RCSC Middle School **HVAC Replacement**

Project # 2025.0008
January 13, 2026

ADDENDUM NO. A-3

FIRST FLOOR MECHANICAL PLAN - UNIT B
SCALE: 1/8" = 1'-0"
NORTH

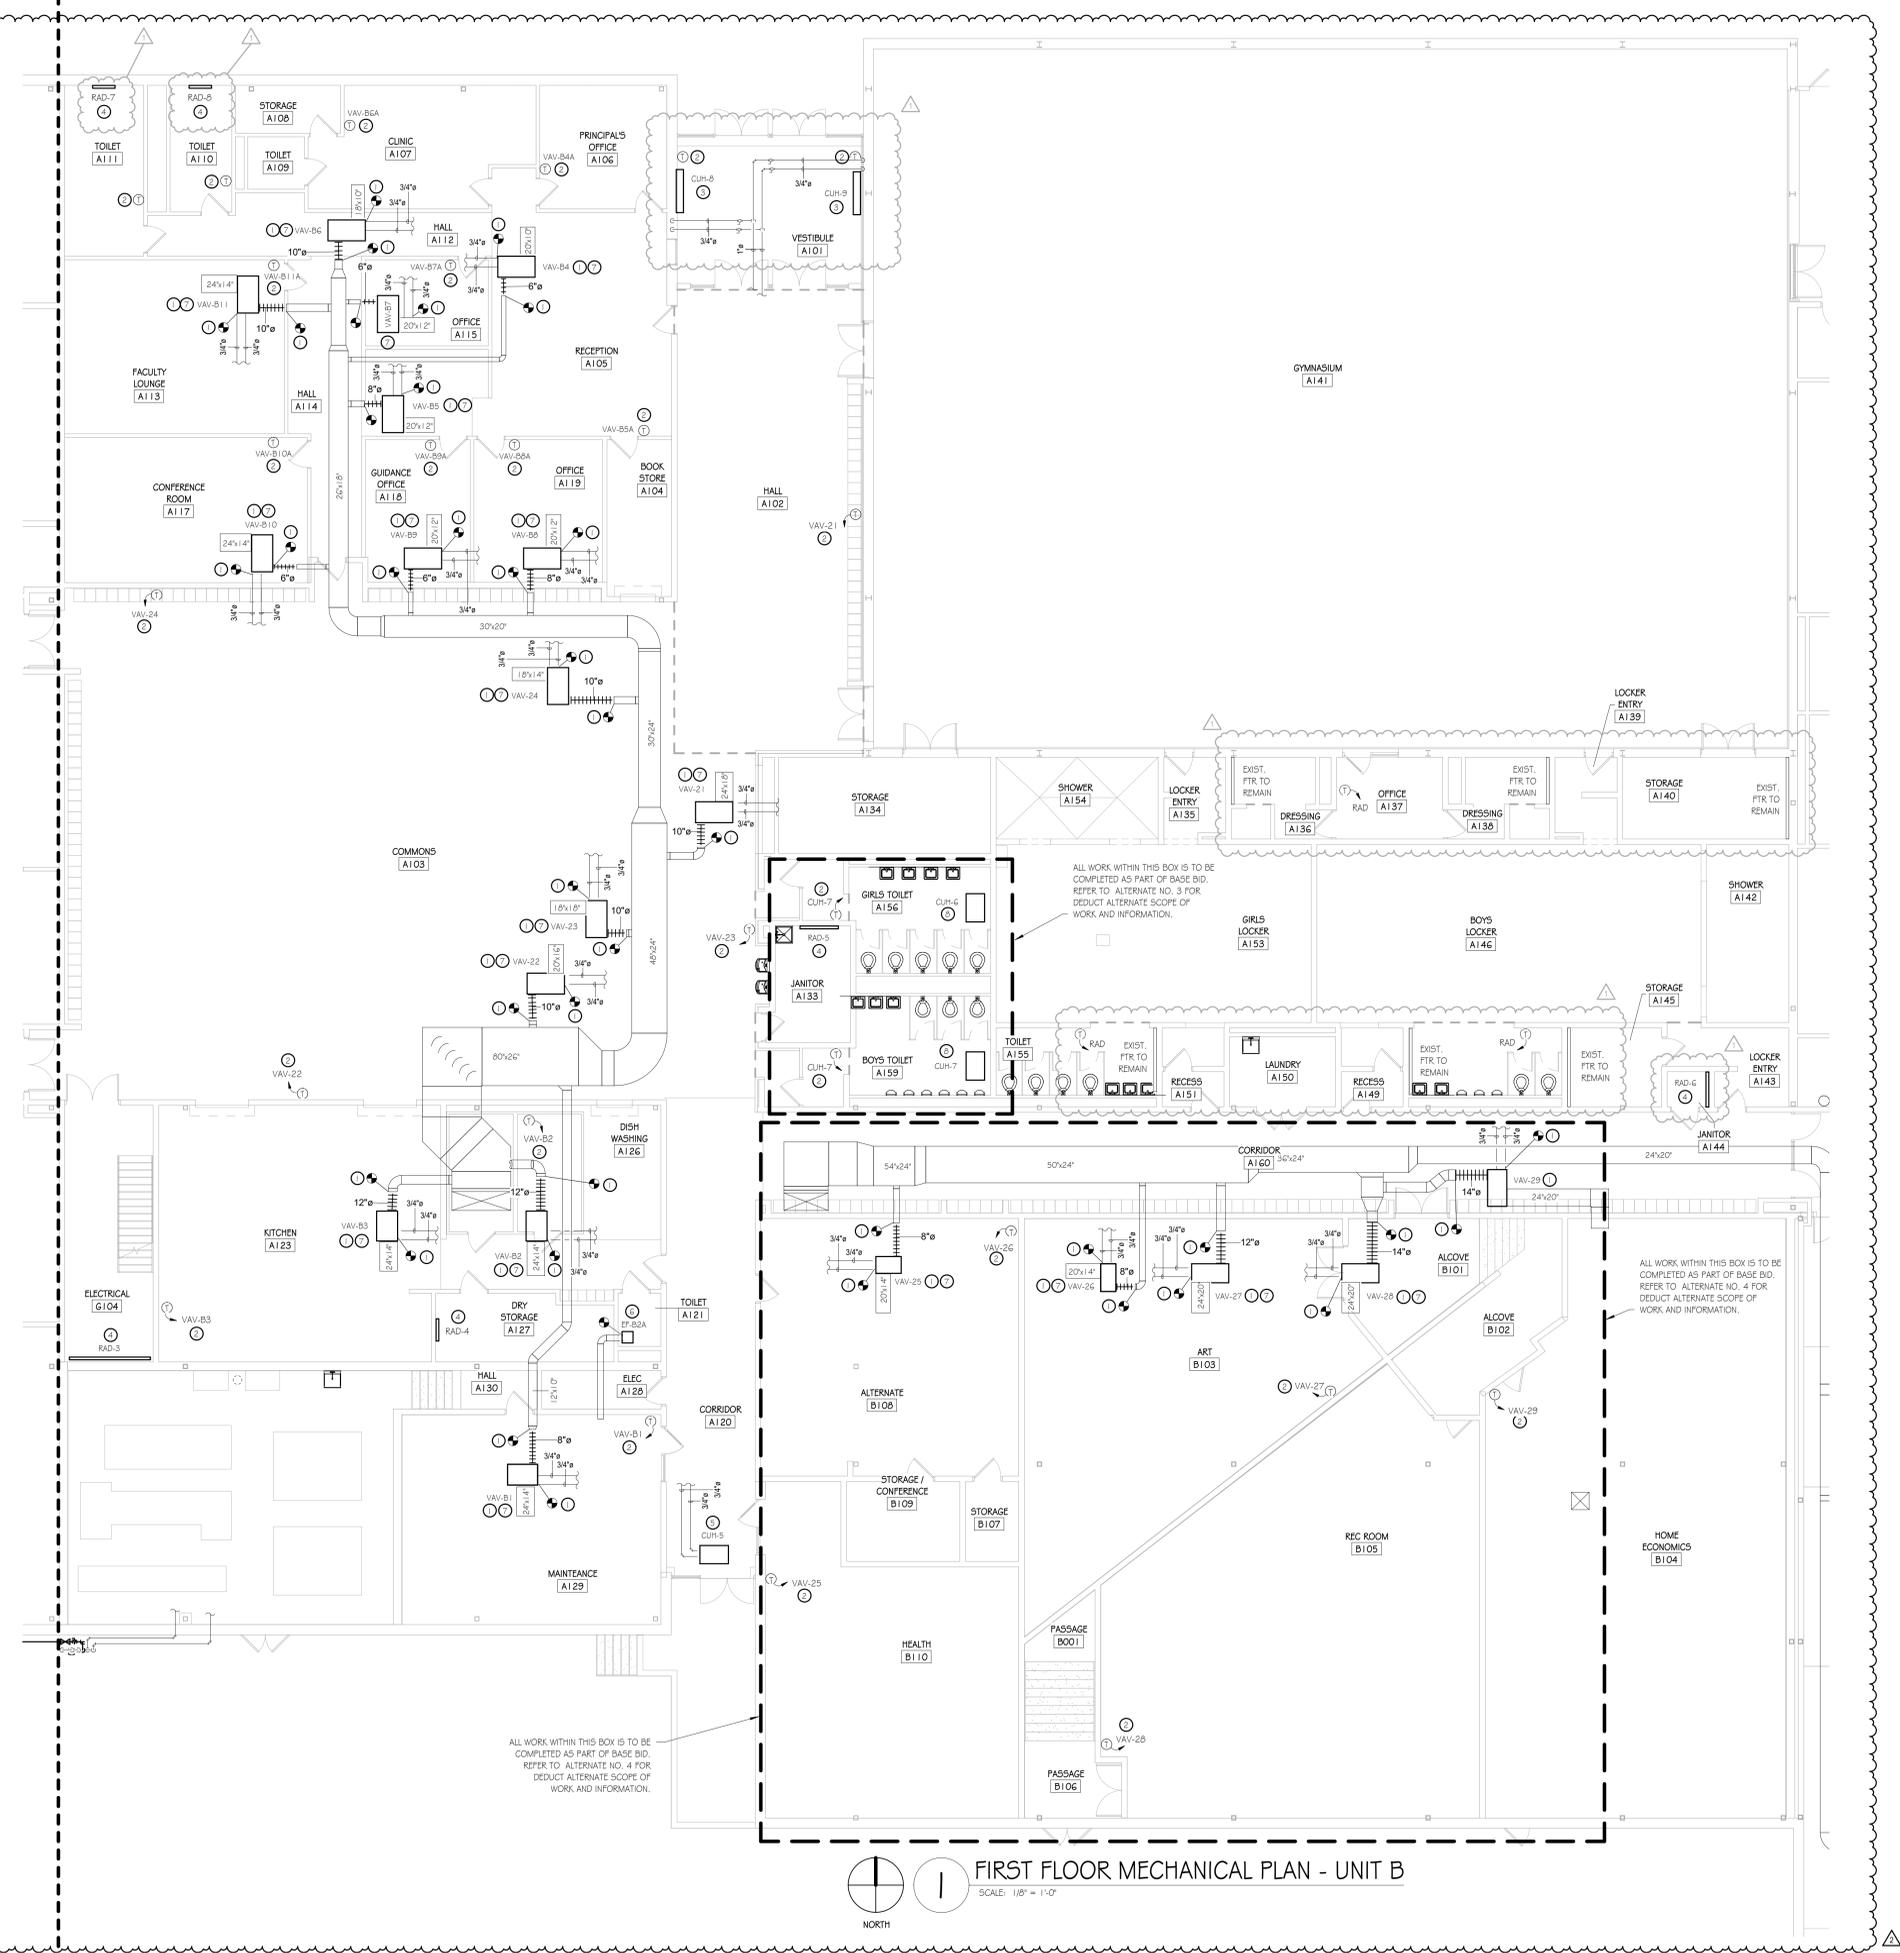
Item: **M-3.6**
Location: Mechanical Drawings: M1.1B.
Description: Revision: Revise the First Floor Mechanical Plan – Unit B as shown on the attached revised sheet M1.1B. Added hydronic piping size tags to the hot water piping that is connected to the VAV's and CUH's. All piping that is connected to the fin tube radiators is to be $\frac{3}{4}$ " \varnothing per the original documents.

FIRST FLOOR MECHANICAL PLAN - UNIT C
 SCALE: 1/8" = 1'-0"
 NORTH

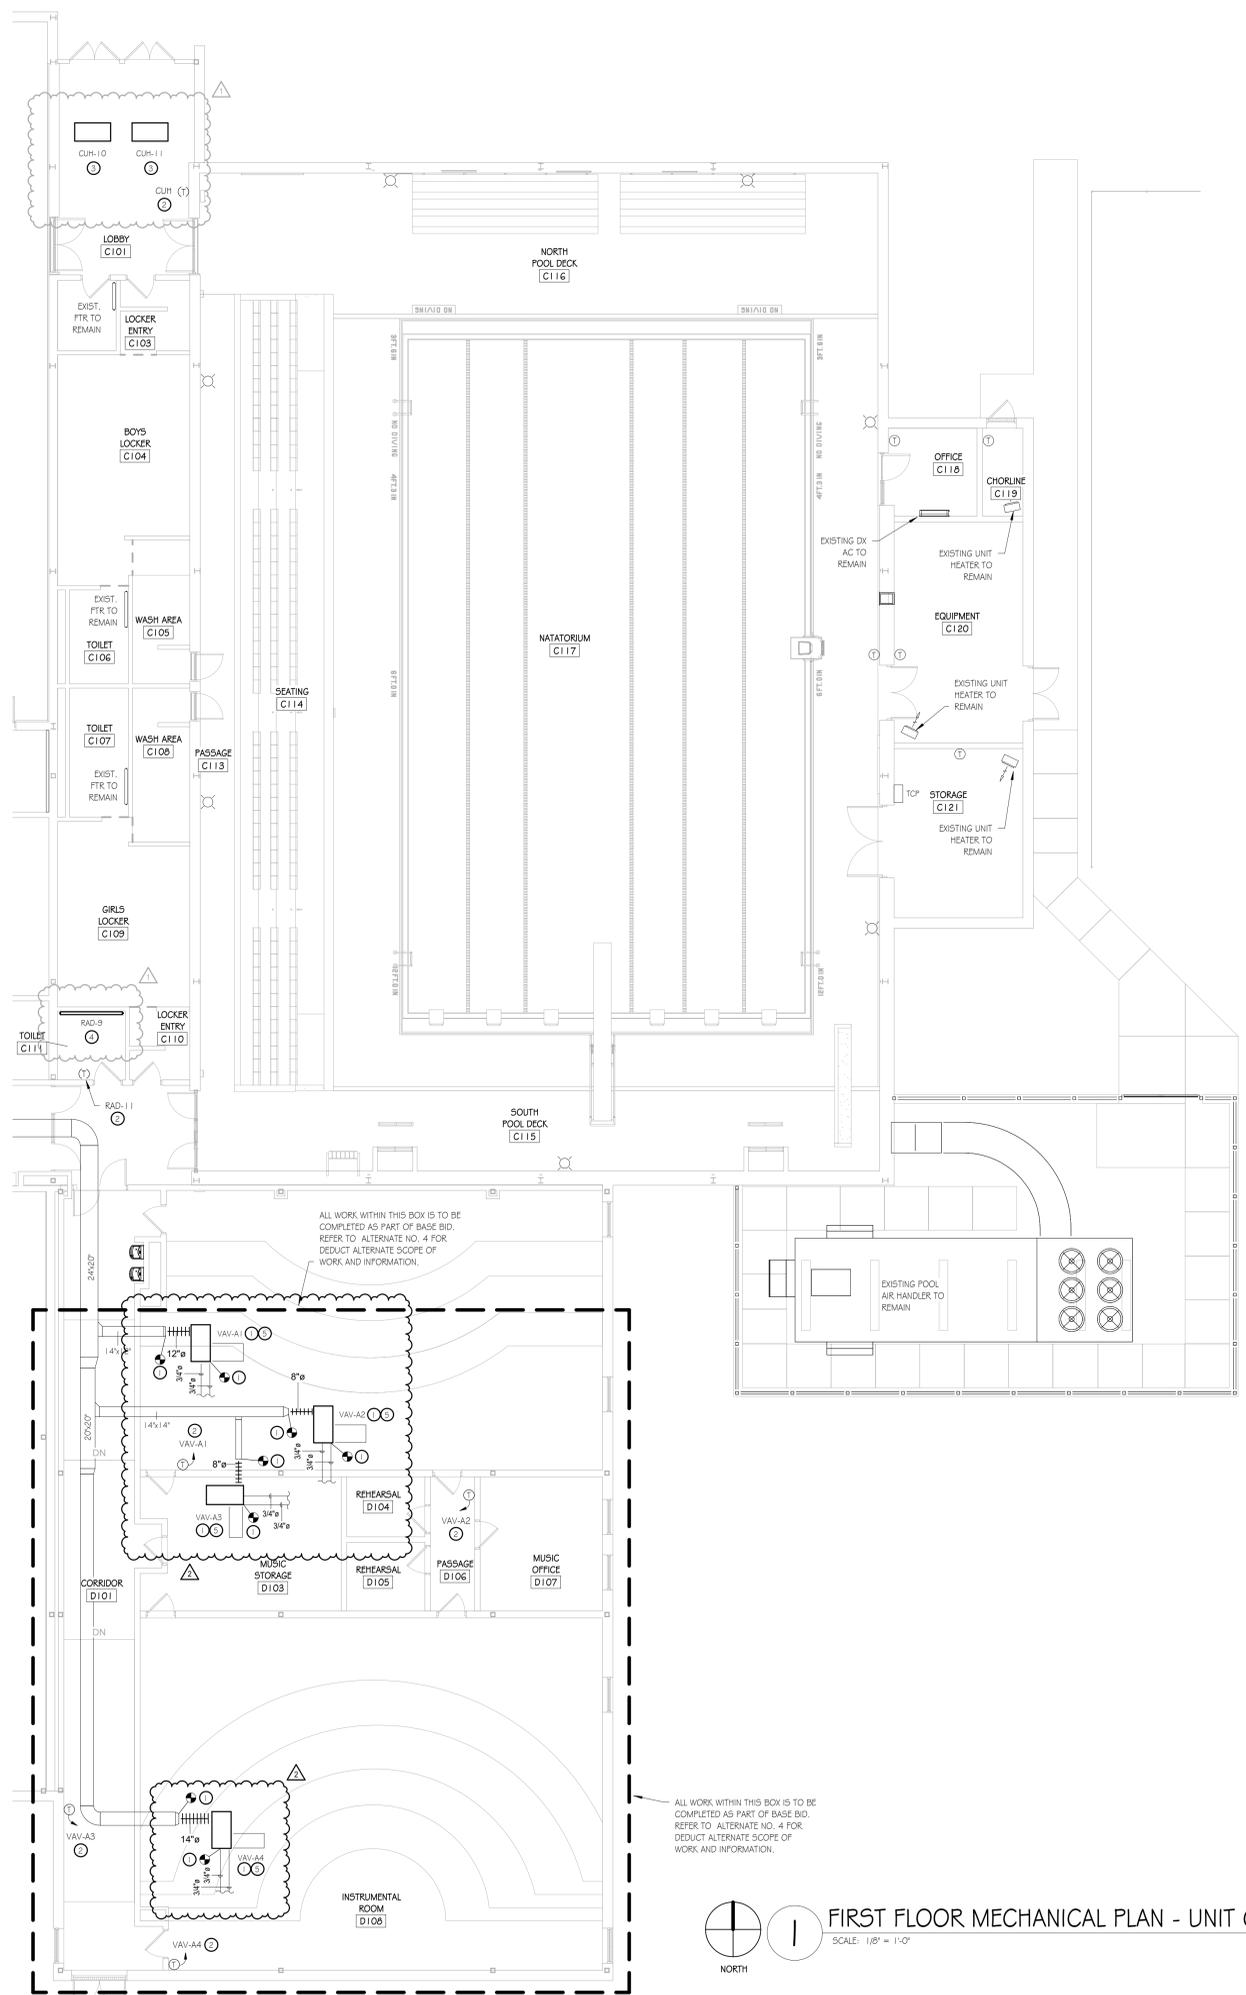
Item: **M-3.7**
Location: Mechanical Drawings: M1.1C.
Description: Revision: Revise the First Floor Mechanical Plan – Unit C as shown on the attached revised sheet M1.1C. Added hydronic piping size tags to the hot water piping that is connected to the VAV's and CUH's. All piping that is connected to the fin tube radiators is to be $\frac{3}{4}$ " \varnothing per the original documents.

PENTHOUSE MECHANICAL PLAN
SCALE: 1/4" = 1'-0"
NORTH

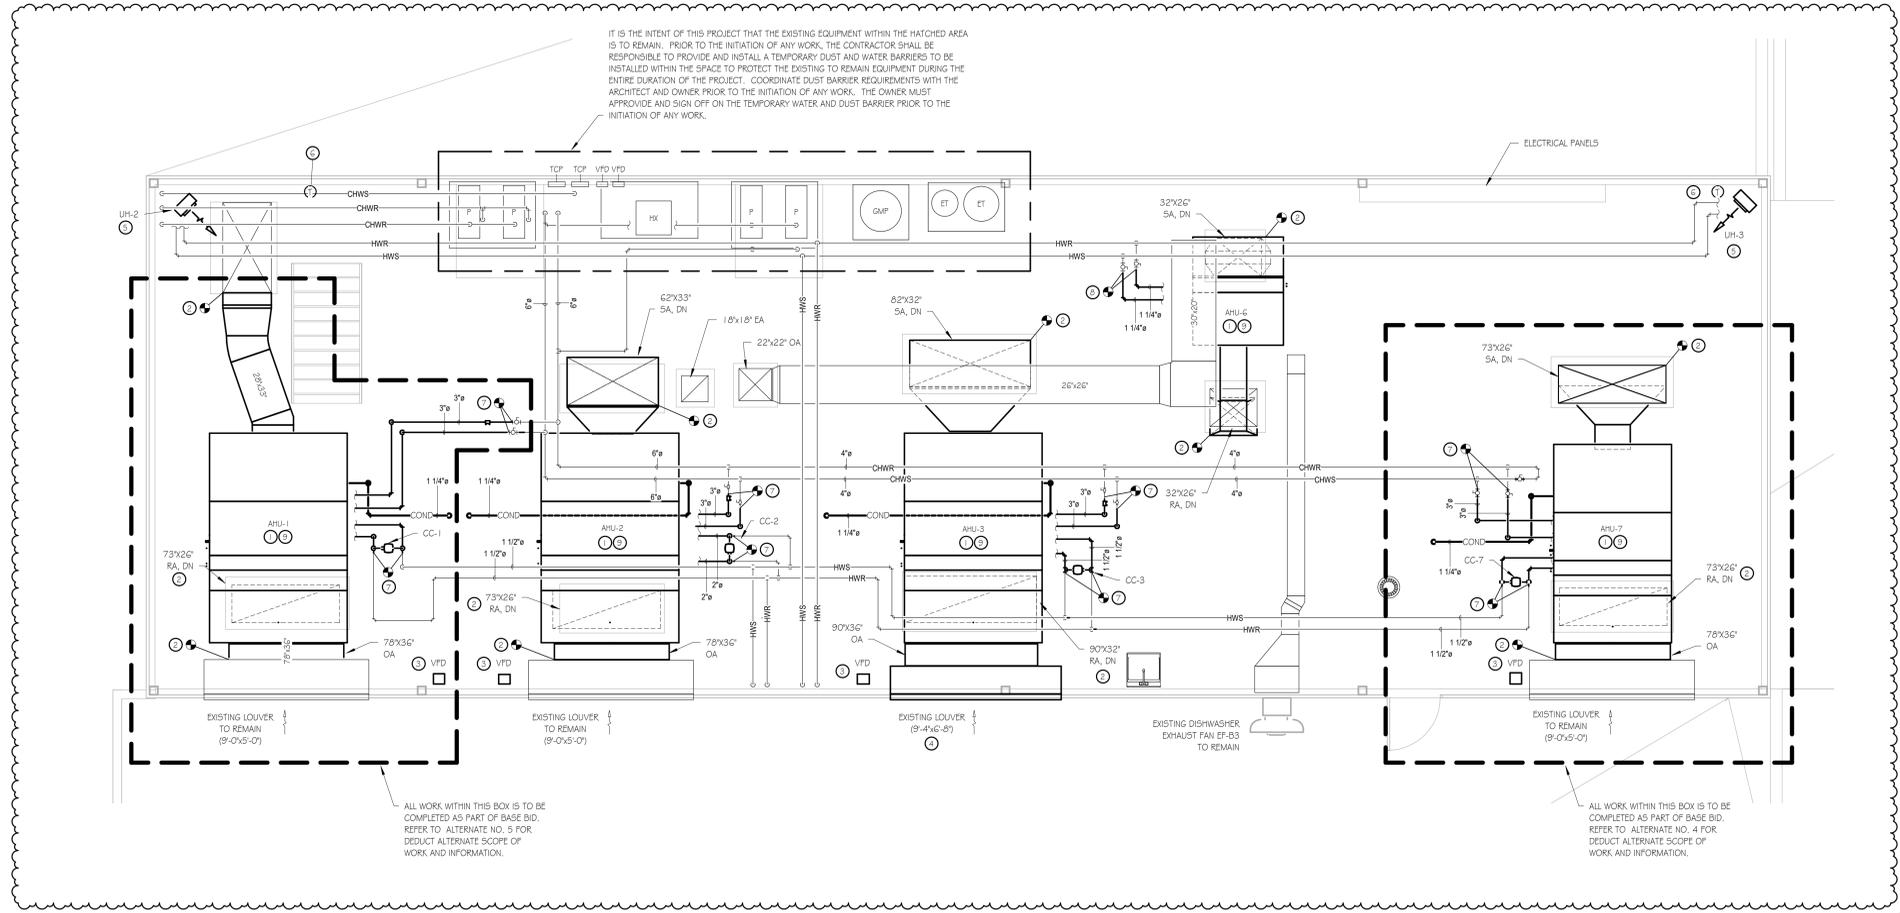
Item: **M-3.8**
Location: Mechanical Drawings: M1.2
Description: Revision: Revise the Penthouse Mechanical Plan as shown on the attached revised sheet M1.2. Added hydronic piping size tags to the chilled water, hot water, and condensate piping that is connected to the air handling units.

Item: **M-3.9**
Location: Mechanical Drawings: M1.2
Description: Revision: Revise the Penthouse Mechanical Plan as shown on the attached revised sheet M1.2. Added a dashed scope box around air handling unit, AHU-1 to show the extent of work that is to be included in Alternate #5.
